TLCCG Questions and Answers  
Tullamarine Landfill Aftercare  
Environment Audit  
1 July 2018 to 30 June 2019

EPA CARM's No. 62139-4

4 March 2021 Meeting

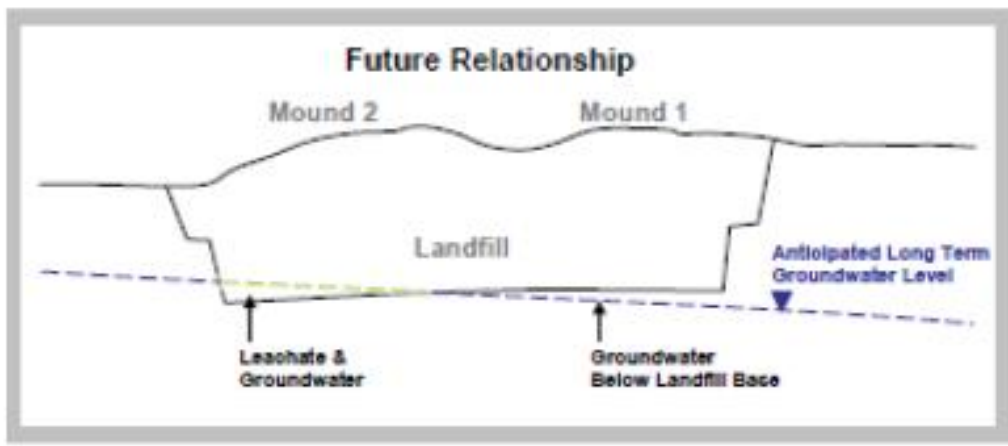
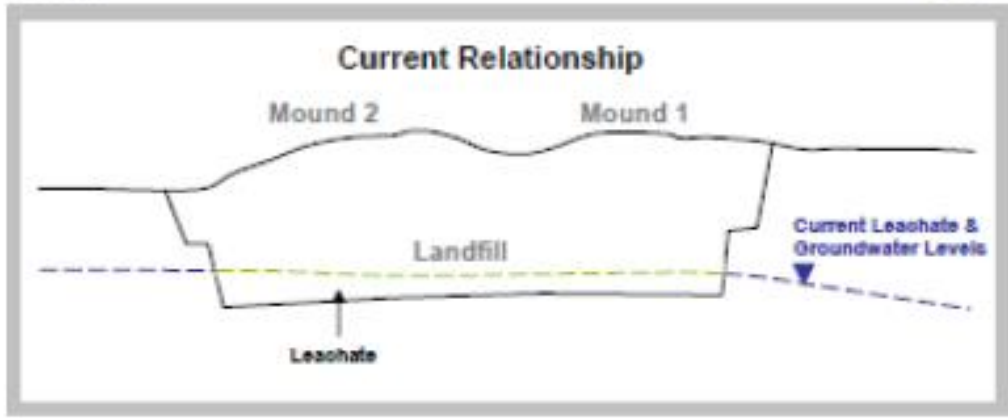
Could the Auditor please elaborate on how she concluded that the set leachate level was unachievable? What is the new level set in the 28/2/21 PCMP? Can you offer any reason why this “impossible to achieve” level was not noticed before?

- The set leachate level of 86.95 m AHD is unachievable because:
  - The base of the waste in Mound 1 and Mound 2 sits at approx. 88 AHD (1.05 m above the set leachate target level).
  - Base of waste in Mound 3 is approx. 92 m AHD (5.05 m above the set leachate target level). Mound 3 received solid waste only, and is reported to be dry i.e. there is no “leachate” in Mound 3.
  - The historical (pre-landfilling) groundwater elevation within Mound 2 is approx. 89 mAHD (2.05 m above the set leachate target level). Continuous extraction of leachate and groundwater would be required within Mound 2, indefinitely, to draw the leachate down to 86.95 mAHD.
  - The historical (pre-landfilling) groundwater elevation within Mound 1 is approx. 87 mAHD.
  - Refer to the following slide.

Information sourced from the 2007 Hydrogeological Conceptual Model and Numerical Groundwater Model prepared by Golder Associates.

**Figure No:** 5  
**Title:** Extent of Onsite LNAPL  
**Project:** Tullamarine Landfill Post Closure Audit 2018-2019  
**Location:** 206-300 Western Avenue, Melbourne Airport, VIC 3045  
**Client:** Cleanaway Solid Waste

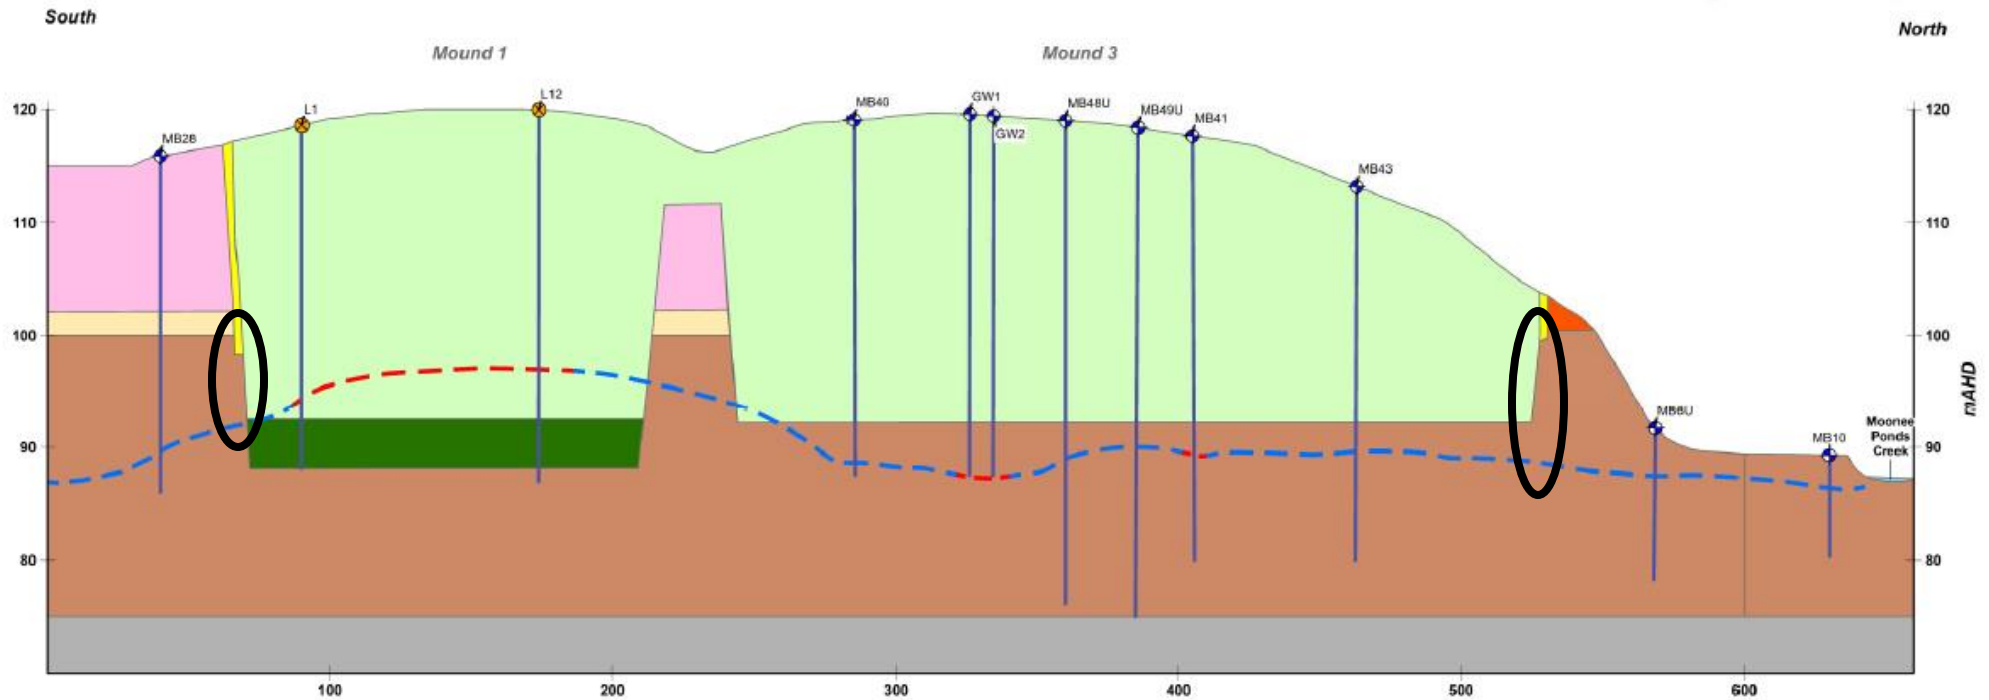
- ***LNAPL is a general term applying to non-water soluble less dense than water liquids floating on water. It appears that the NSZD concept arises from a relative non fatal perspective. However, where the LNAPL contains known carcinogens natural depletion is unacceptable especially to a nearby community and where the LNAPL can find its way into the groundwater flow. Given that community requests for the LNAPL to be removed and treated when it was freely mobile were not agreed what processes and procedures are in place for the next 100 – 200+ (refer Anthony Lane Preliminary Risk Assessment 2004) years to ensure the LNAPL will not pose a risk the nearby communities while it, hopefully, depletes naturally? How can the community be assured that somewhere in the next 100 - 200 + years the corporate (and public) memory will not be lost and the Dump becomes a disaster in waiting? (6)***

- The LNAPL footprint under and around the landfill has not changed.
- The LNAPL continues to be detected in the same groundwater bores under Mound 3 and to the east of Mound 3 and Mound 1.

- The LNAPL has not moved off site since it was deposited at the site (pre 1990), even when leachate hydraulic gradients within the landfill were much higher i.e. when greater leachate mounding in the landfill could have mobilised it.

- The LNAPL present on leachate in Mounds 1 and 2 and on groundwater under Mound 3 has been sitting below the extent of the clay side liner for some time and off site movement has not been detected.

- Natural source zone depletion of the LNAPL is occurring approximately 20 m below ground level, hence the risk of exposure to the LNAPL or its degradation by-products is low.

Reference - Table - 10-1: Landfill Gas Perimeter Bore Groups (original wells) - page 105 - (p 121 of 176)

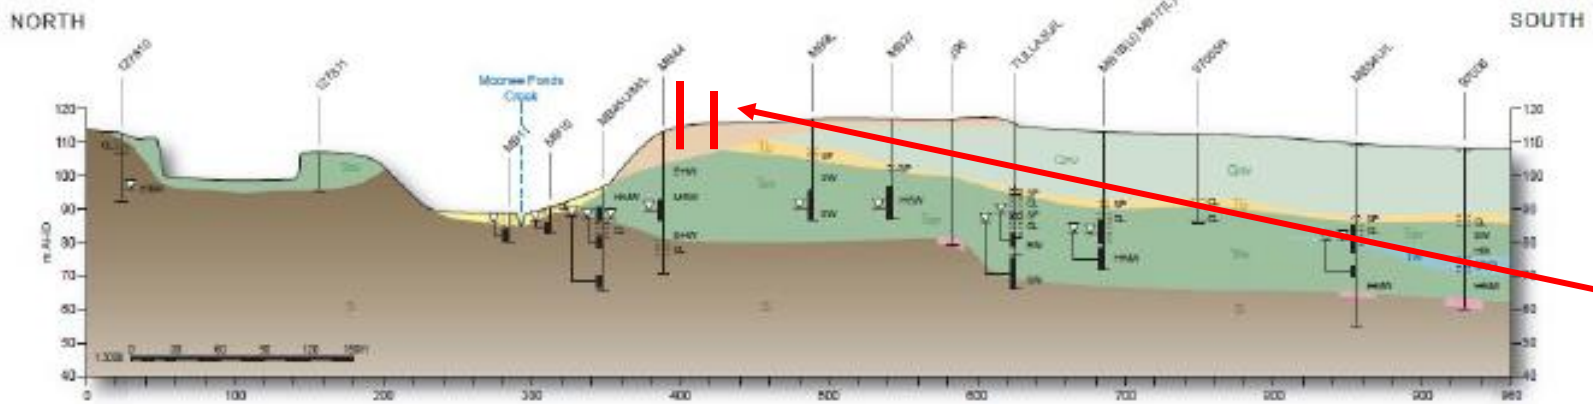
- ***It is presumed the heading FILL in the table refers to soil placed between the finished cap and the surrounding undisturbed ground. Is this correct? (14)***

Fill comprises imported material placed over natural soil or rock. It is not specifically related to the cap.

Some shallow perimeter landfill gas monitoring bores are located in the fill that is present outside the landfill cap extent.
